STAFF REPORT: 7/14/2021 MEETING P APPLICATION NUMBER: #21-7357 ADDRESS: 2225 WABASH HISTORIC DISTRICT: CORKTOWN APPLICANT: TIMOTHY FLINTOFF (4545 ARCHITECTURE) PROPERTY OWNER: DIANE ZIEGER (ZEIGER PROPERTIES, LLC) DATE OF PROVISIONALLY COMPLETE APPLICATION: 06/21/2021 DATE OF STAFF SITE VISIT: 6/25/2021

SCOPE: INSTALL CARPORT

RE: 2225 Wabash St - New Construction Historic District Commission Submission

ARCHITECTURAL SITE PLAN SCALE: 1"=10'-0"

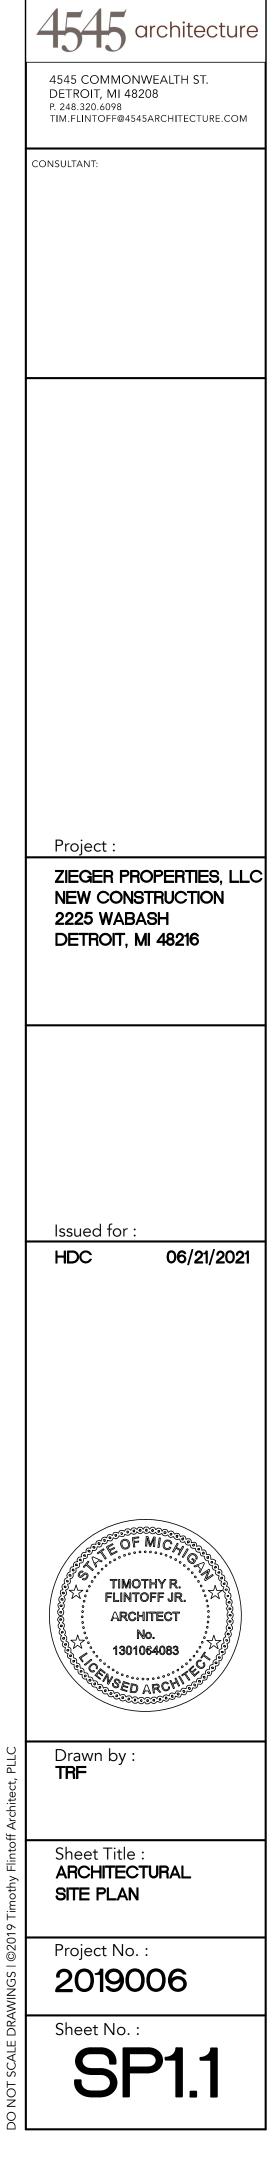
- It is staff's opinion that this proposal is consistent with the design and scale of the house.
- The visibility of this carport is obscured from the public right-of-way, excepting the alley.

- It is staff's opinion that the materials, contemporary character, and size are appropriate for the existing context of this particular parcel.

HDC staff recommends the Commission issue a Certificate of Appropriateness for the proposed carport because it meets the Secretary of the Interior's Standards for Rehabilitation and conform to the Elements of Design for the Corktown Historic District.
